**Howard County
Health Department**

RECEIPT DATE: 12-11-25 **ONSITE SEWAGE DISPOSAL SYSTEM** P 590298

PROPERTY ADDRESS: 11935 Simpson Road, Clarksville, MD. 21029

The OSDS Plan for **11935 Simpson Road** has been reviewed with the following comments:

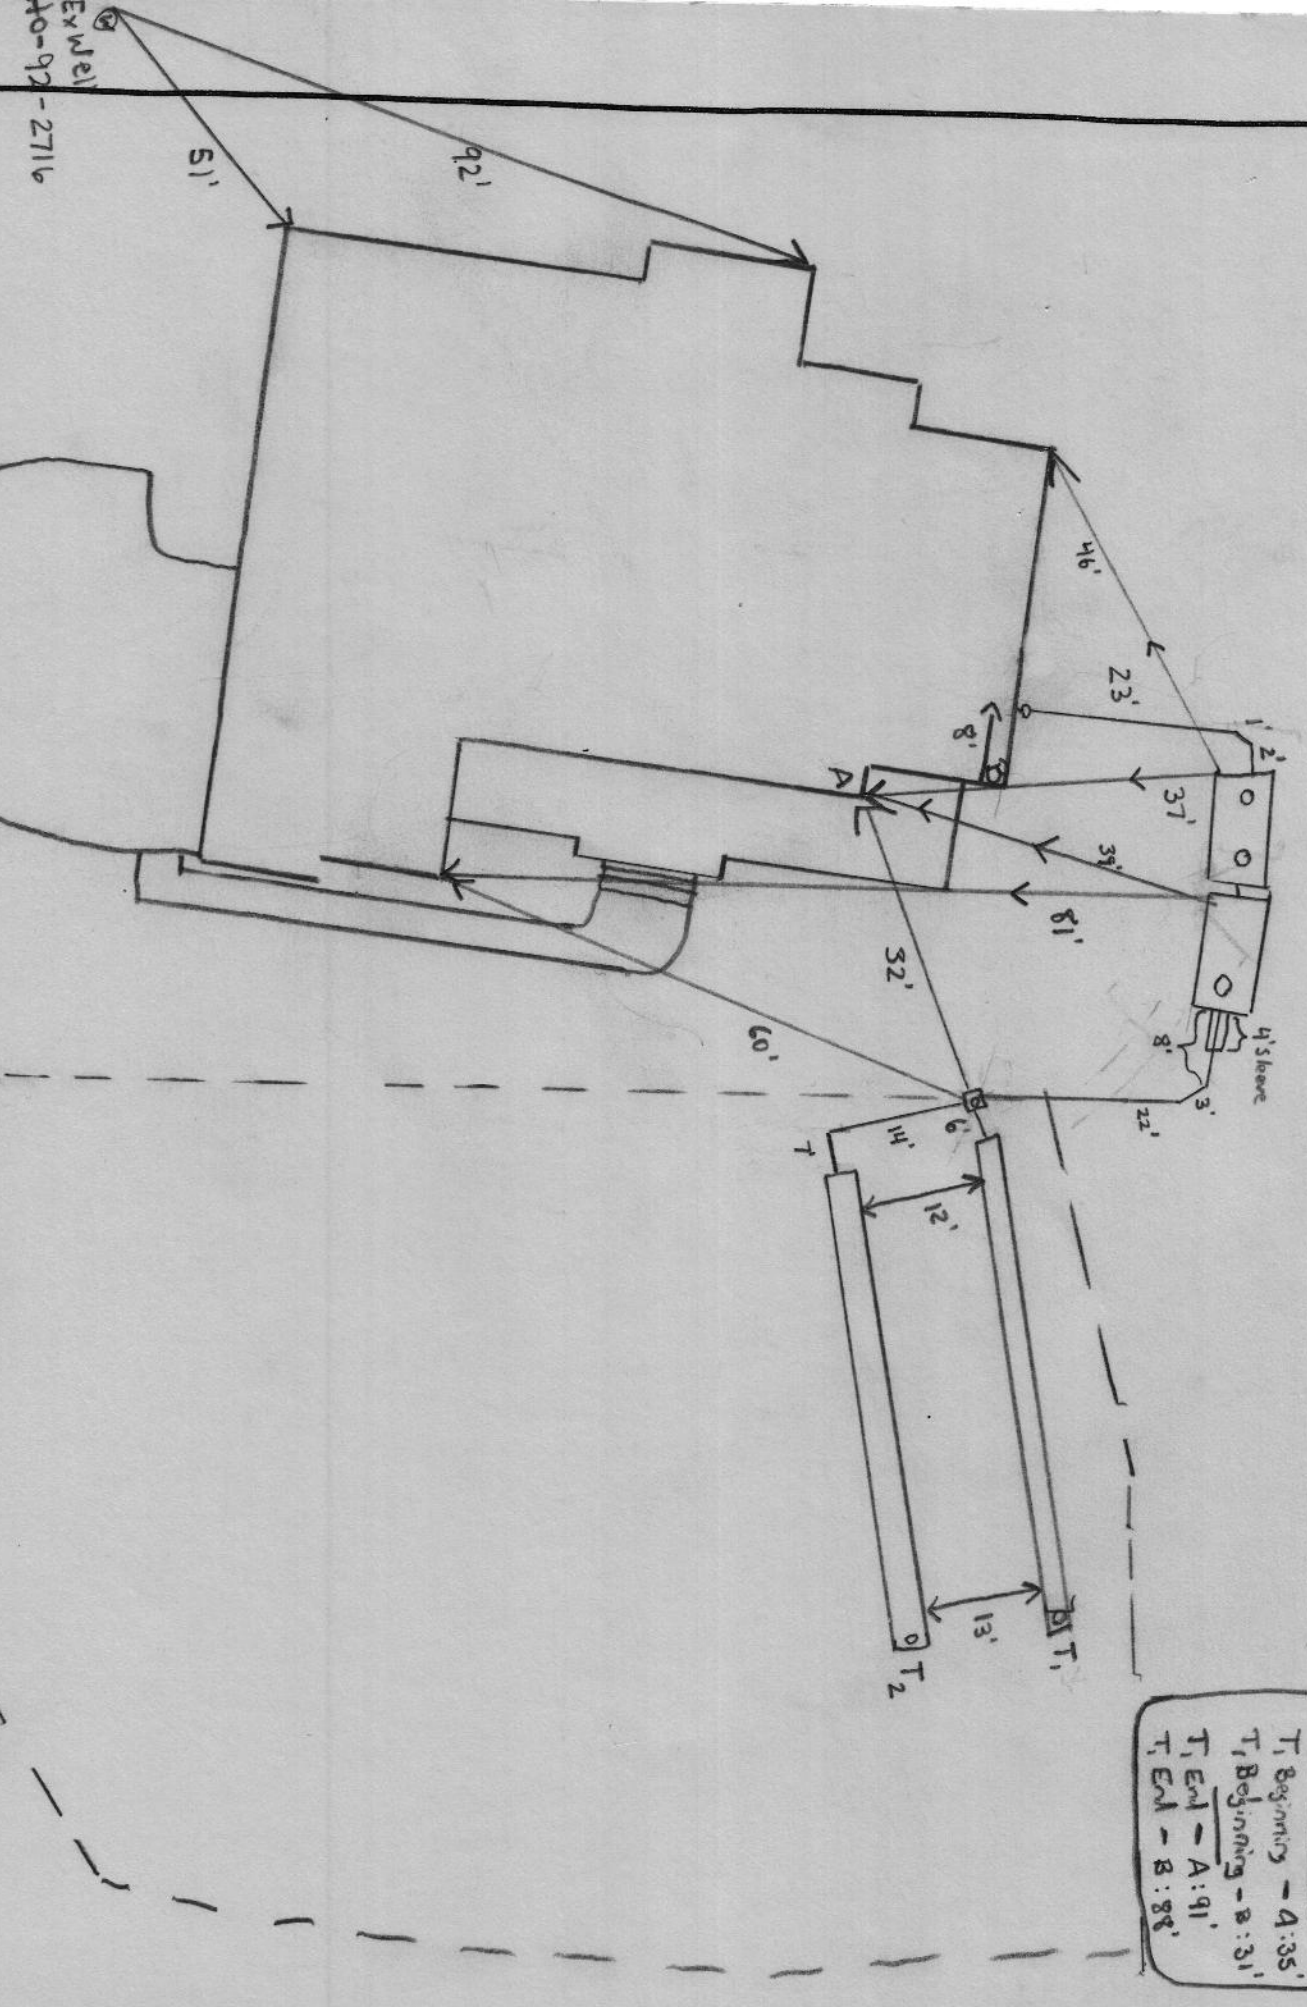
1/23/26 Pump tank delivered NOT TO SCALE
 Tank is level. 2" line to d-box is sloped 4' out of pump tank and
 connected to d-box. Contractor added a 90° bend to direct water down/side
 in d-box. Hydraulic cement used for pipe connections into d-box
 2" gate valve installed on pump tank 2" line. Pump on 6" block. Only 3'
 back riser on pump tank. OK to backfill. (MB)

3/24/2026 Alarm outside house on wood plank 1/2" above grade. Alarm visible
 + audible OK. Water pumps to d-box OK. (SP) OK. (SP)

PRE-CONSTRUCTION NOTES:
 1/9/26 House shape slightly changed, Sun room added to side of house where septic
 tank to be installed. Well location accurate. SDA trenches, and tanks are staked accurately. There is a 5" dip
 with both trenches close to the fence. Contractor stated he will fill in 5" dip with final grading. Trenches on contour otherwise.
 Will move d-box in front of trench 1. Plan reviewer to speak to engineer for (redlined) OSDS plan (MB)

INSTALLATION NOTES:
 1/27/26 Contractor has trench 1 completed. 8' bottom with about 2.5' inlet, observation port and geotextile fabric added.
 Stone #2 double washed from burrhead and is marginal with some stone dirt. Completed trench 2 excavation while on site.
 8' bottom (MB) 1/27/26 Contractor completed trench 2 2.5' inlet. Trench length @ 50'. Starting SFC now and
 tanks will arrive tomorrow. OK to backfill trenches. Geotextile fabric and observation port installed. (MB)
 1/23/26 Front line installed with clewets and 1/2" fall. Backed in gravel. Septic tank delivered and installed. Tank is level and
 sloped. ST will have 3' cover on it contractor confirmed. Adding 3' risers. Will have to grade to get down to 3' due to landscape.
 Vertical pump floats correct per plan. (MB)
